SAFETY ALERT

September 26, 2013

Subject/Purpose

DESCRIPTION:	RUDDER PEDAL SAFETY ALERT	
	MATERIAL : 4130 or MILD STEEL	t=0.050"
	COPYRIGHT © 2013 ZENITH AIRCRAFT Co.	DATE: 9-26-2013

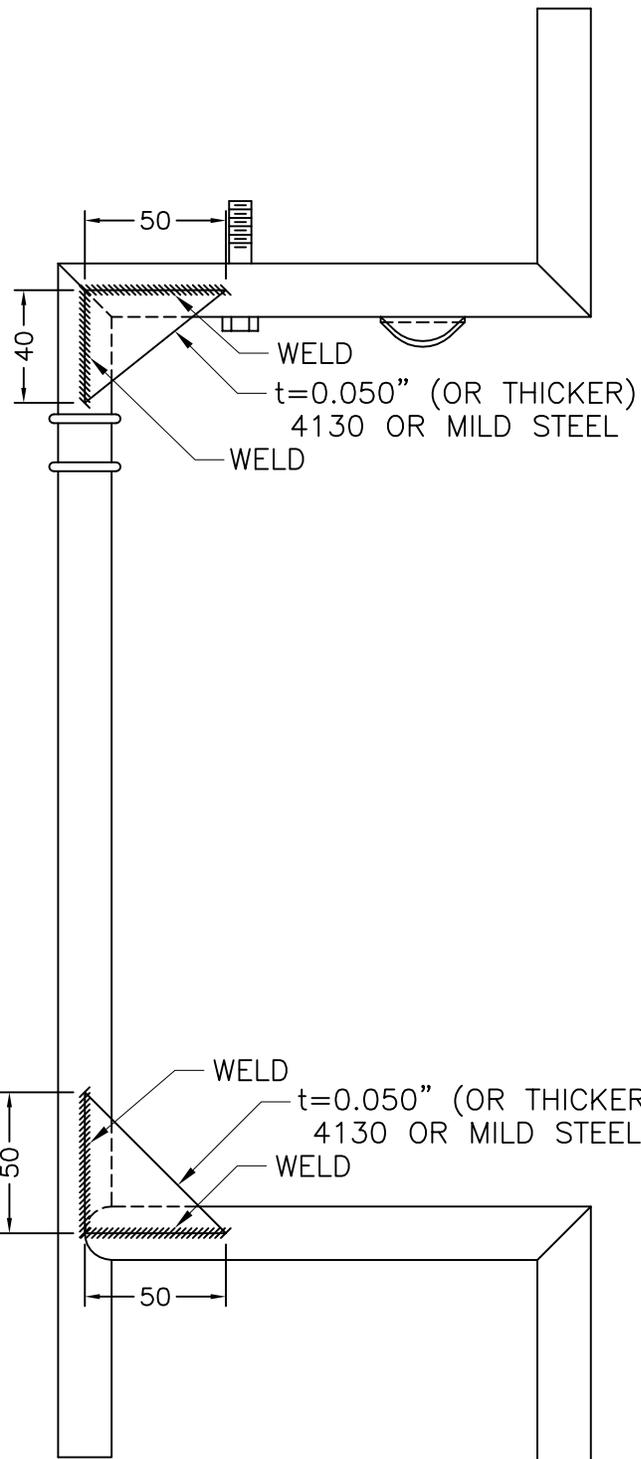
We have received reports of several rudder pedal deformations and failures recently from an overseas operator. Upon inspection of the failed rudder pedals it was discovered that some of the 4130 chrome-moly tubes used in the welded rudder pedals assembly was thinner than prescribed in the aircraft drawings (0.035-inch wall thickness instead of 0.058-inch wall thickness).

If you have determined that your rudder pedals do not comply, gussets must be welded to the front and aft sides of the lower horizontal tube and vertical tube as shown in the following drawing.

INSTALL GUSSETS ON FRONT AND AFT SIDE OF TUBES
